STEPHENSON PUBLIC LIBRARY RENOVATION AND ADDITION
1700 HALL AVENUE MARINETTE, WISCONSIN 54143

SHEET TITLE: REFLECTED CEILING PLAN

SHEET NUMBER: A302

2 ALT. CEILING PLAN
NTS
*ALL ACOUSTICAL TILE IN THIS ALTERNATE IS A FIRE RATED ASSEBLY

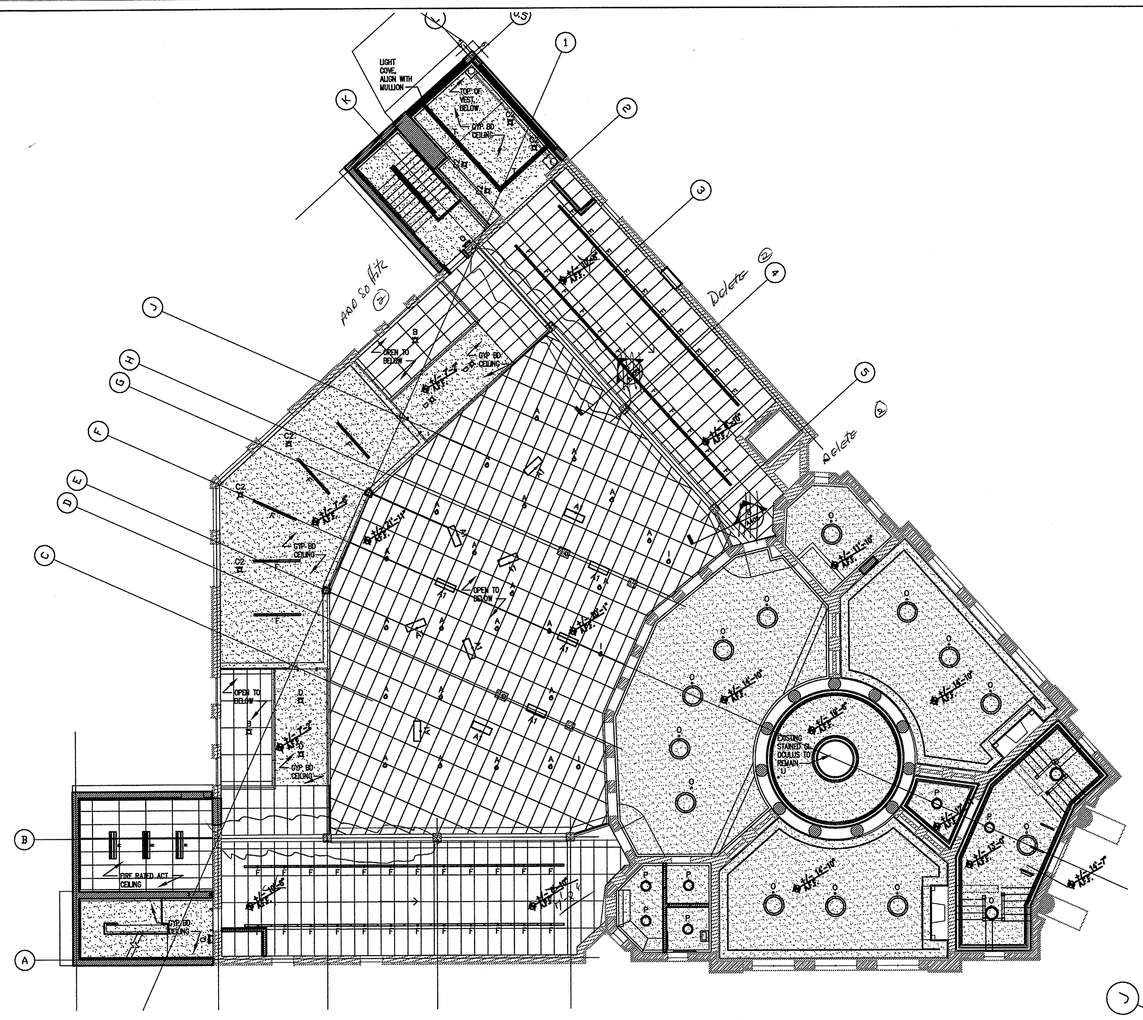
ITEM NO. 12 – REFER TO SHEET A302 "REFLECTED CEILING PLAN"
A. DETAIL 2 THE HISTORIC 1903 BUILDING CEILINGS ARE PLASTER TO REMAIN AS SHOWN IN DETAIL 1.
B. DETAIL 2 THE FIRE RATED ACCOUSTICAL TILE IS TO BE 2X2.

1 SECOND FLOOR REFLECTED PLAN
1/8" = 1'-0"

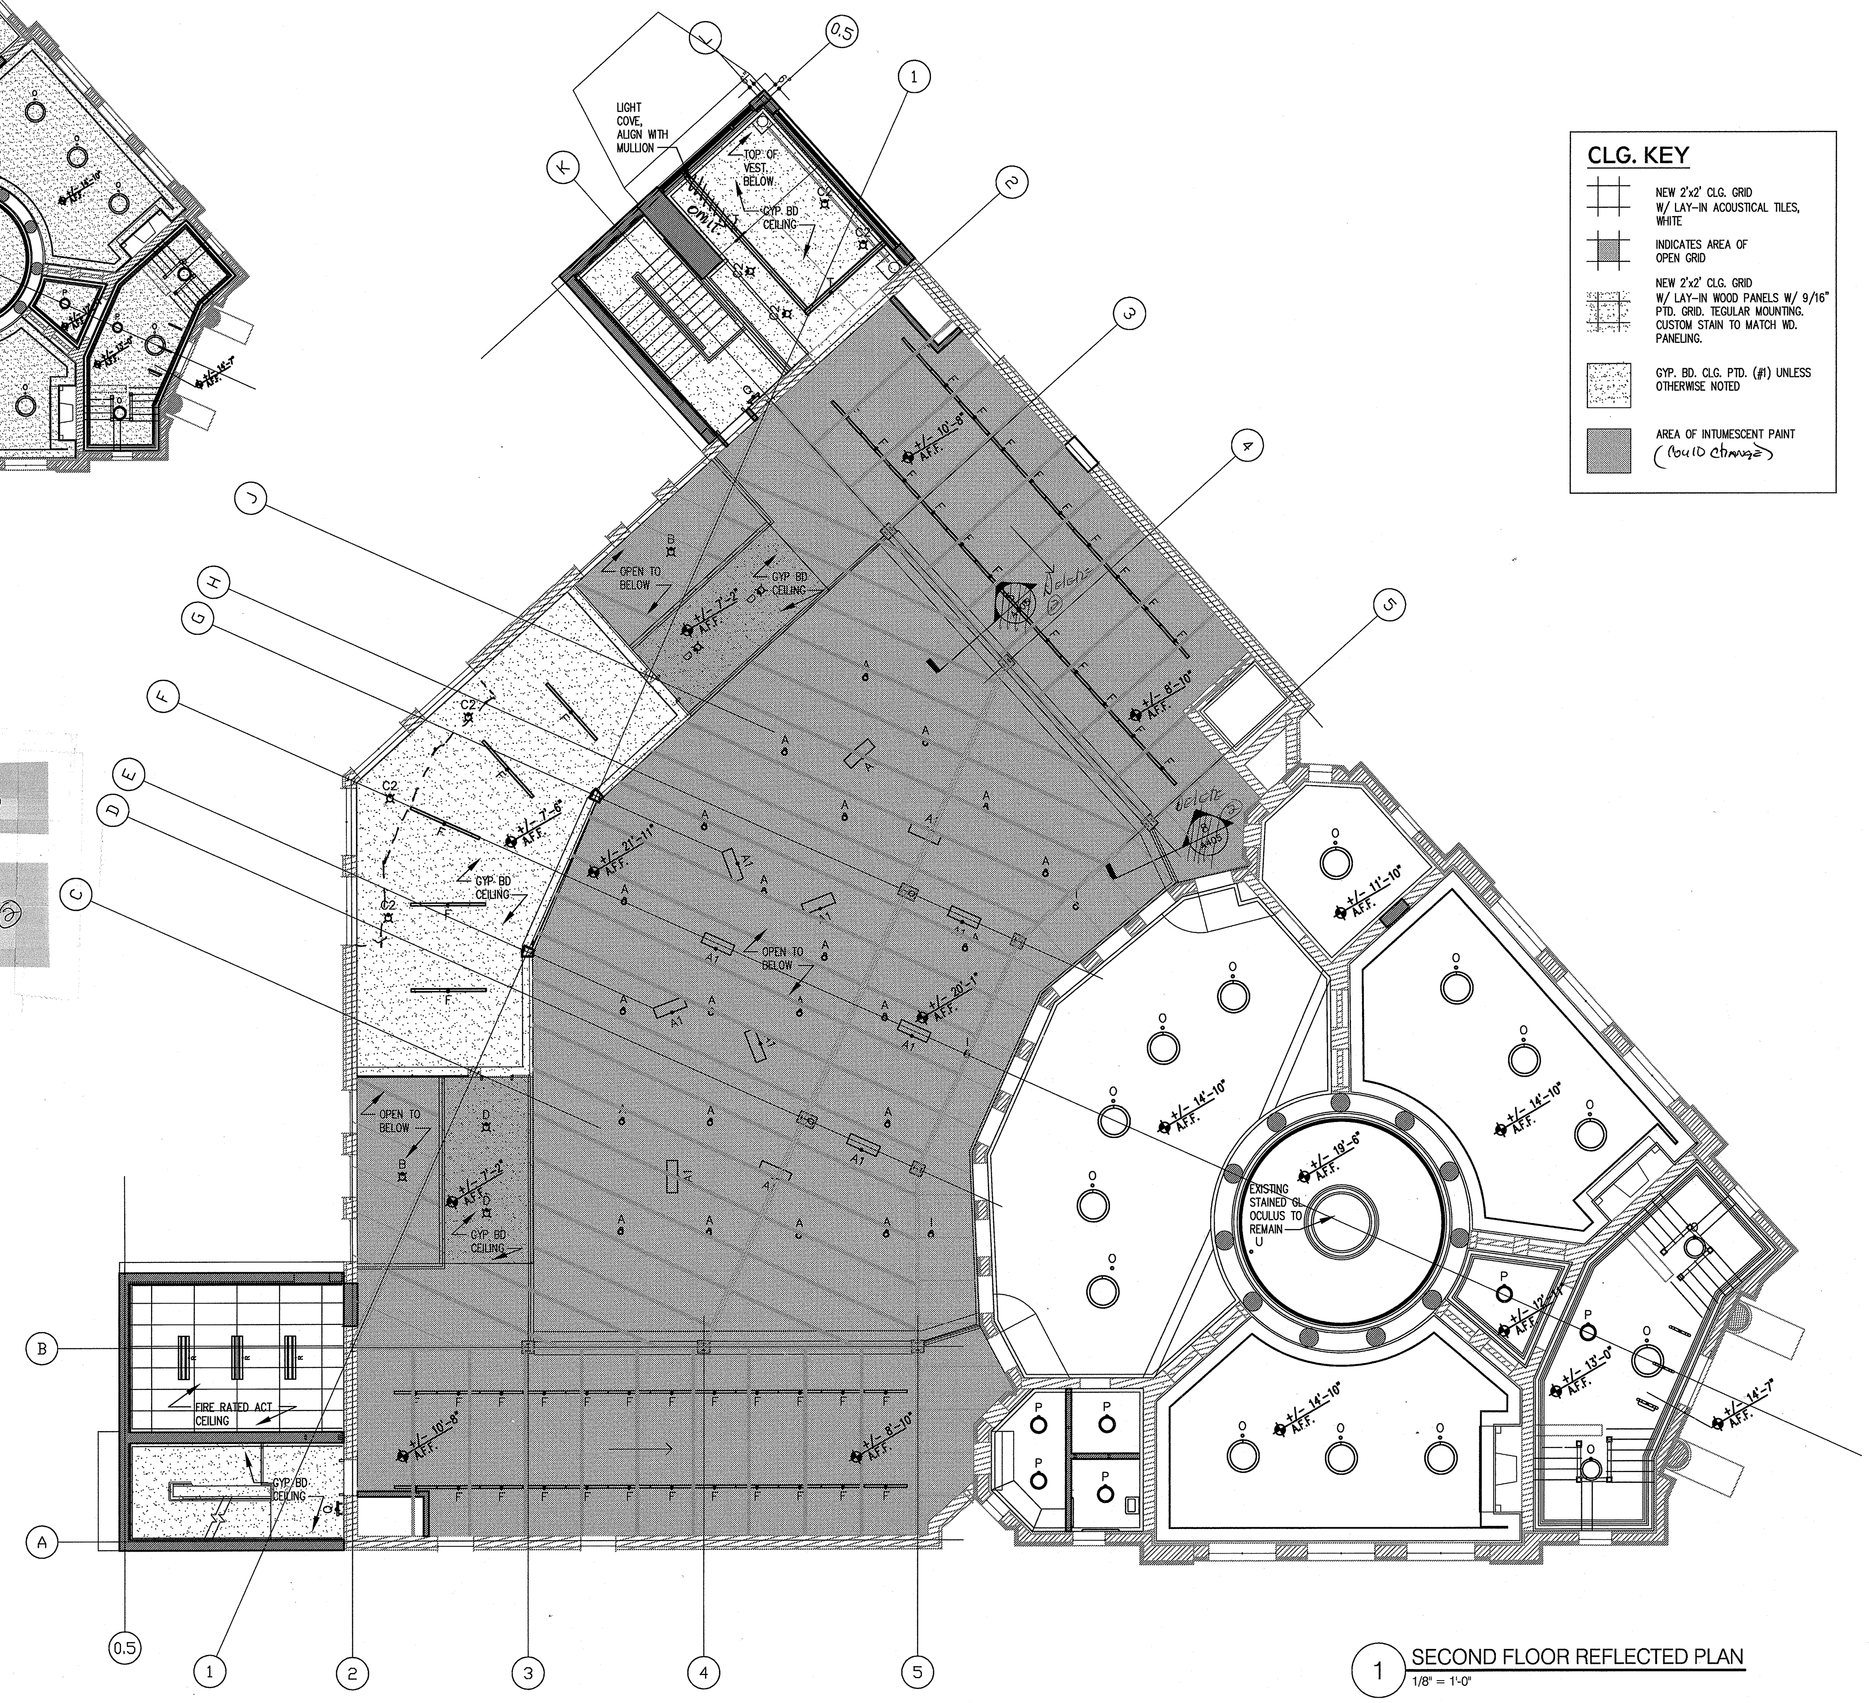
ITEM NO. 7 – REFER TO SHEET A302 "REFLECTED CEILING PLAN"
A. DETAIL 2: DELETE CEILING ELEVATION TAGS IN 1979 BUILDING. CEILING IS 7'-8" AFF OF MEZZANINE LEVEL
B. DETAIL 2: ADD GYP BD SOFFITS AT 7'-2" AFF MEZZANINE LEVEL AT STEEL BEAMS ALONG GRID LINES B, K, & 4. CONSTRUCTION TO BE 2 LAYERS 5/8" GYP BD ON 1 5/8" METAL STUDS
C. DETAIL 1: DELETE TWO SECTION CUTS ALONG COLUMN LINE K
D. DETAIL 1 & DETAIL 2: BOTH FIRE RESISTIVE SYSTEMS ARE TO PROVIDE A 1-HR FIRE RATING.
